Service Bulletin 592

Issue 1 - 01.2022

Subject: Re-torque Rear Sprocket Lock Nuts				
Bulletin Number	Models Affected	VIN Range		Markets Affected
592	Bonneville T100	From AX0150	To AX8715	All markets except Brazil and India
	Bonneville T120	From AX3748	To AX8997	
	Bonneville T120 Black	From AX3794	To AX9221	
	Street Scrambler	From AX3104	To AX8892	
	Street Twin	From AX3271	To AX9003	
	Thruxton RS	From AX3796	To AX9387	
	Speed Twin	From AX2845	To AX9202	
	Bonneville Bobber	From AX4245	To AX8709	
	Bonneville Speedmaster	From AX4277	To AX8985	
	Tiger Sport	From AW9349	To AX9217	
	Trident	From AX3686	To AX9241

1. Lock nut (5 of 6 shown)
2. Sprocket - chain not shown for clarity (Bonneville T120 shown)

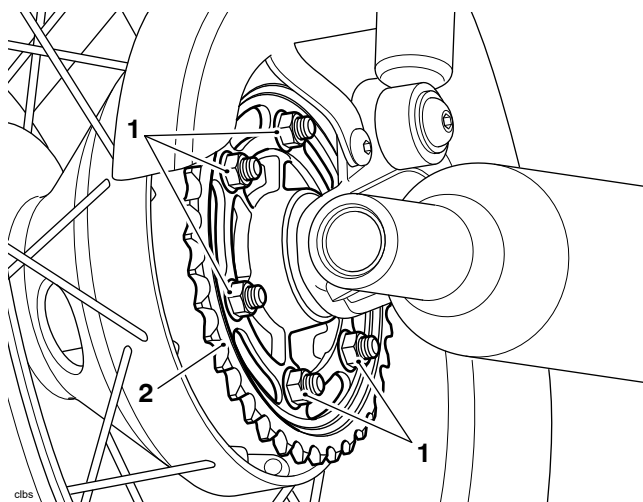
1. Evenly and progressively re-torque the rear sprocket lock nuts to **55 Nm**.
